INDESIT company

MBM1721VFR

F036360

General notes

N1030093fig1

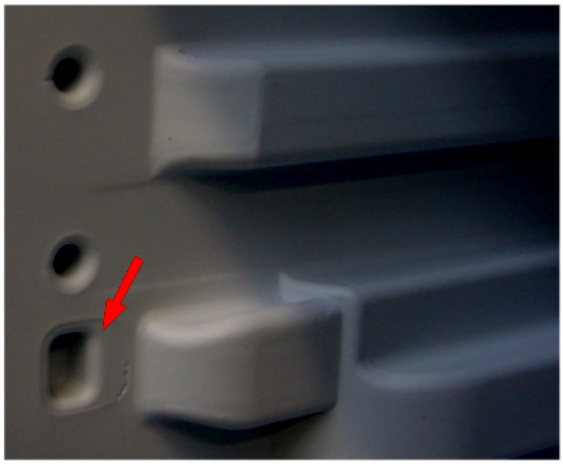
n1030093: New fixing of evaporator on static fridge-freezers (05 range) 60 cm,Melano

From August 05 (serial no. 50802.0001) the freezer evaporator is secured to the cabinet by a plastic profile.
The cabinet walls have been modified to create locations to house the profile, which is installed on the front of each evaporator plate (see photo N1030093fig1- fig2 - fig3)
The profile cannot be fitted on premodification appliances, so technical personnel must continue to fit the rh and lh supports on these models (see photo N1030093fig4)

New parts
C00141135 = WHITE PROFILE L=443.5 MM

Parts replaced
C00075596 = EVAPORATOR RH SUPPORT
C00075597 = EVAPORATOR LH SUPPORT

N1030093fig1

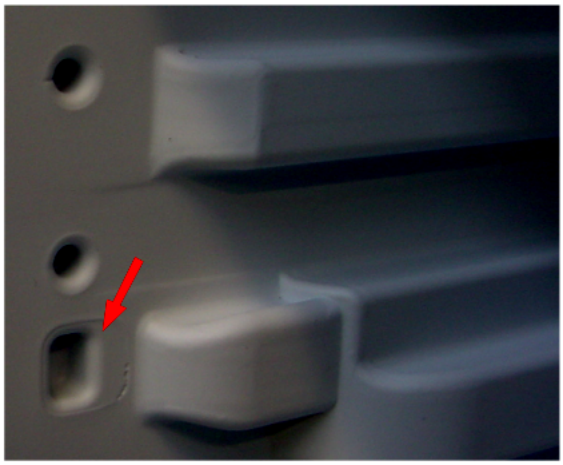
n1030094: New fixing of evaporator on static fridge-freezers (05 range) 60 cm, Lodowek

From August 05 (serial no. 50820.0001) the freezer evaporator is secured to the cabinet by a plastic profile.
The cabinet walls have been modified to create locations to house the profile, which is installed on the front of each evaporator

plate (see photo N1030093fig1- fig2 - fig3)
The profile cannot be fitted on premodification appliances, so technical personnel must continue to fit the rh and lh supports on these models (see photo N1030093fig4)

New parts
C00141135 = WHITE PROFILE L=443.5 MM

Parts replaced
C00075596 = EVAPORATOR RH SUPPORT
C00075597 = EVAPORATOR LH SUPPORT
